**Proposed Temporary Shop and Services with Ancillary Office
for a Period of 5 Years in "Village Type Development" Zone,
Lot 173 RP (Part) in D.D. 109, Kam Hing Wai, Kam Tin, Yuen Long
(Application No. A/YL-KTN/883)**

Compliance with Approval Condition (a)

Appendix I – Response to comments of the Chief Engineer/Mainland North, Drainage Services Department (CE/MN, DSD)

Drainage Proposal - LAYOUT

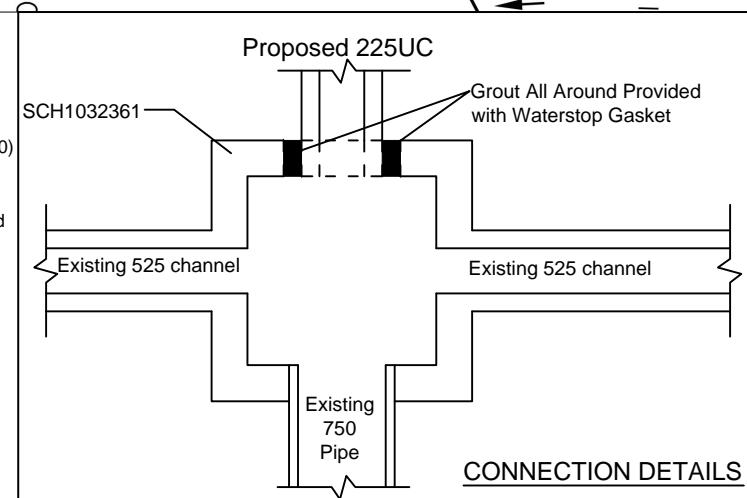
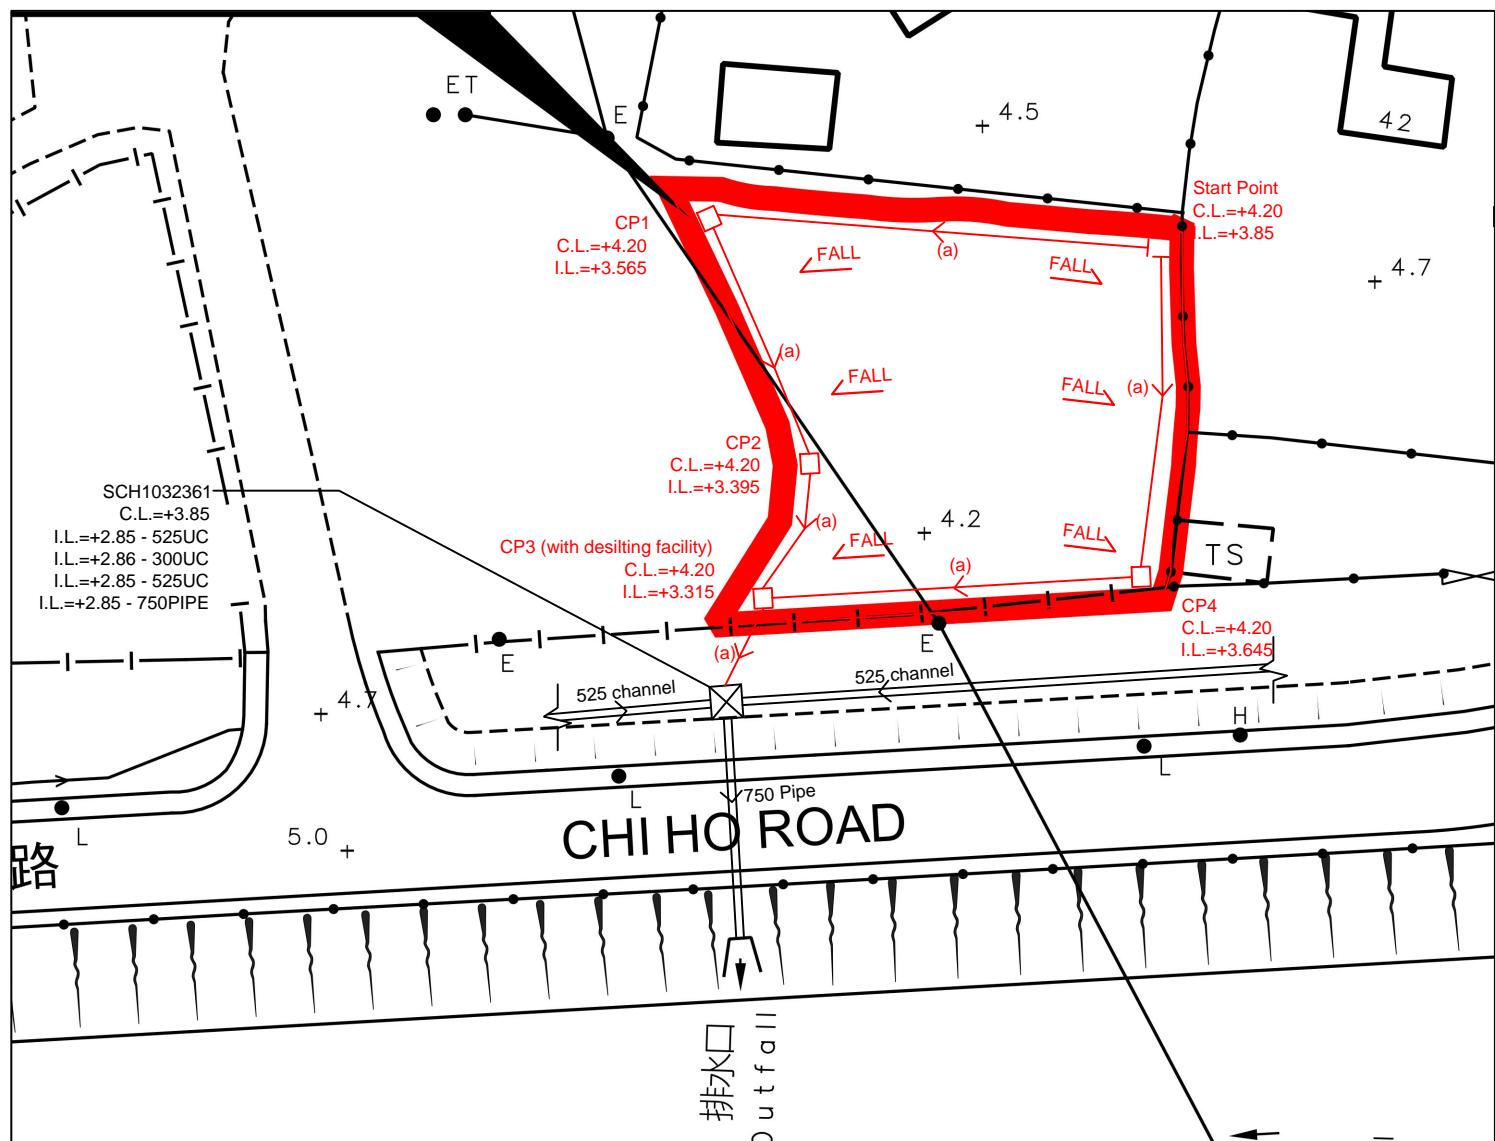
3.	Catchment area plan, including external catchment area, should be provided.	Noted. Catchment area plan is provided.
4.	SCH1032361 details should be shown on layout plan.	Noted. SCH1032361 details are provided.

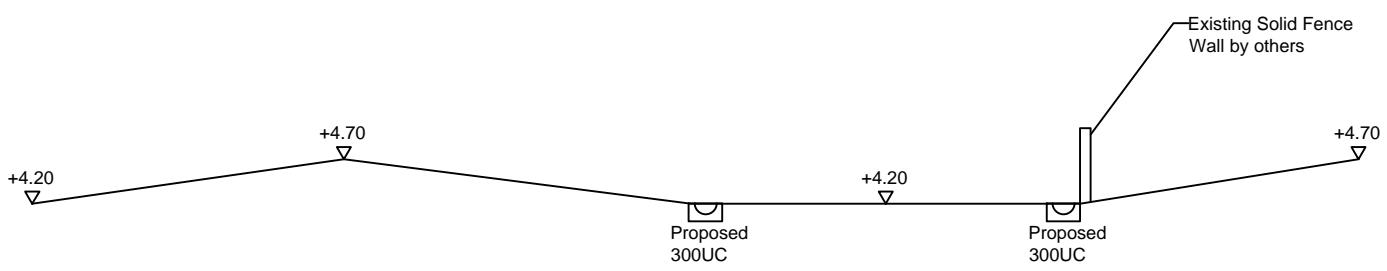
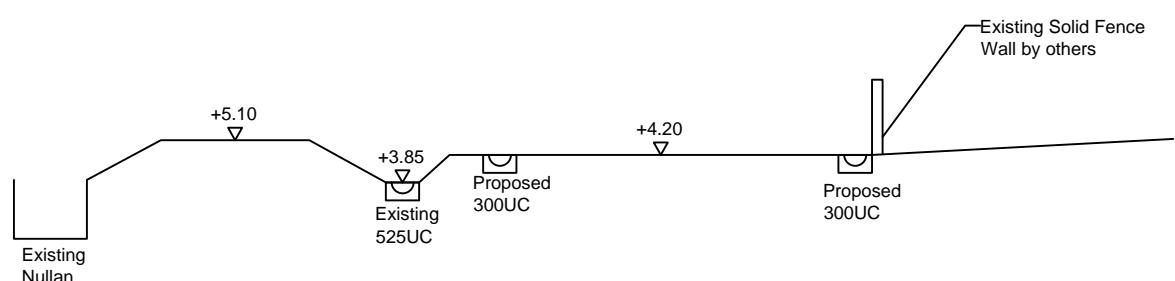
5.	Cross sections showing the existing and proposed ground levels of the captioned site with respect to the adjacent areas	Noted. Cross sections are provided.

Figure 1 - Chart for the rapid design of U-shaped and half-round channels up to 600 mm

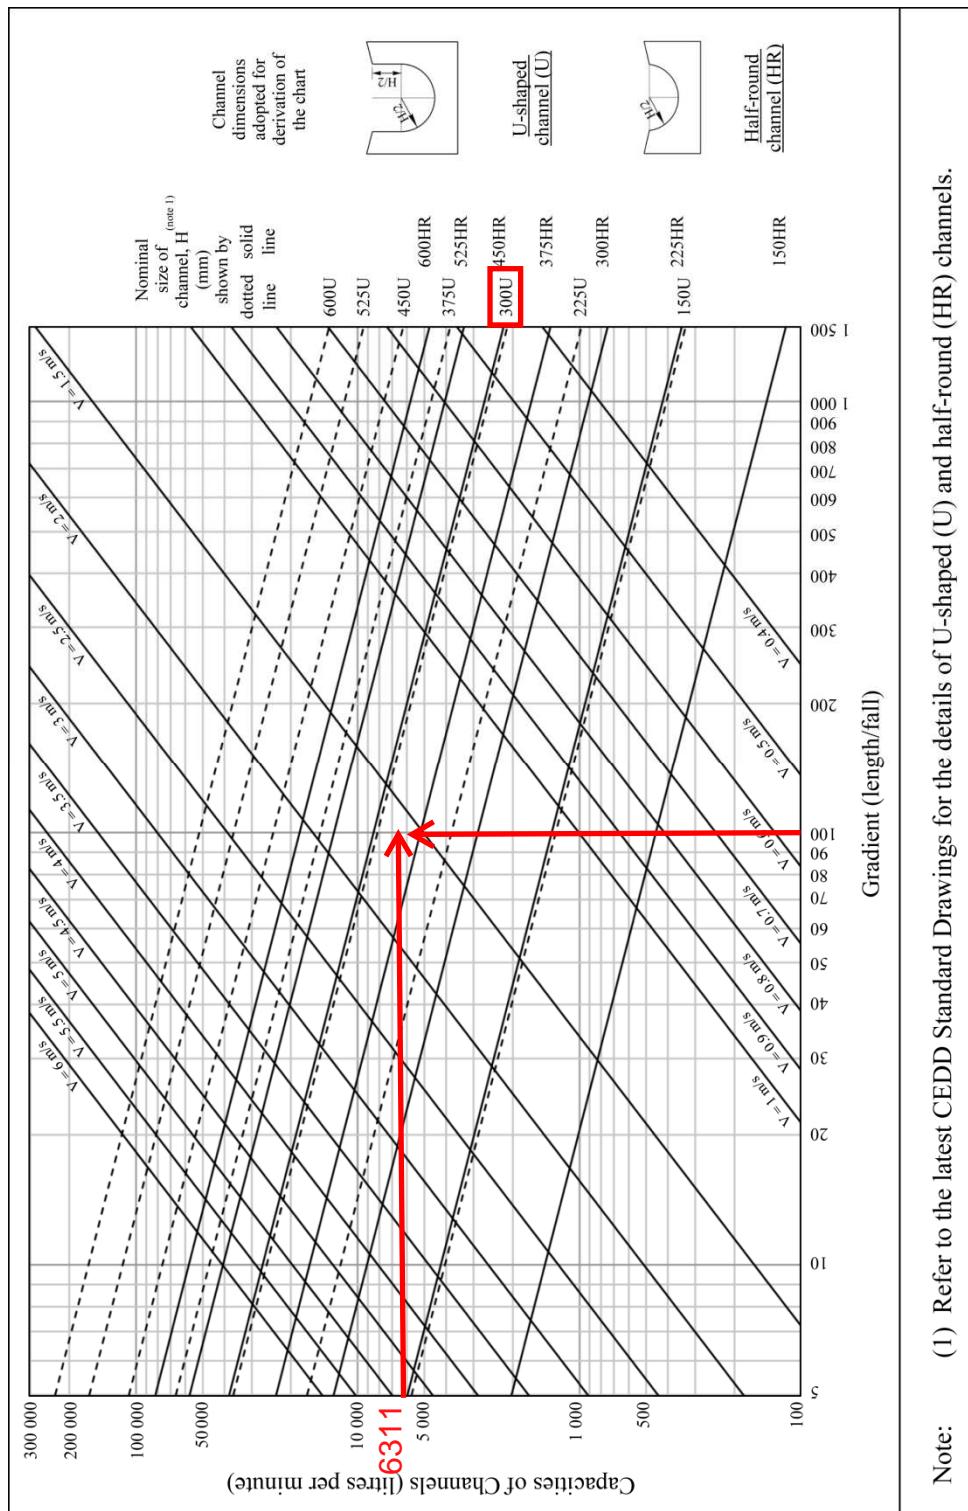
should be given.	
6.	Velocity check (within 0.7m/s to 3m/s) for the proposed u-channel connecting existing SCH1032361.	Noted. Velocity checking is presented in TGN43.
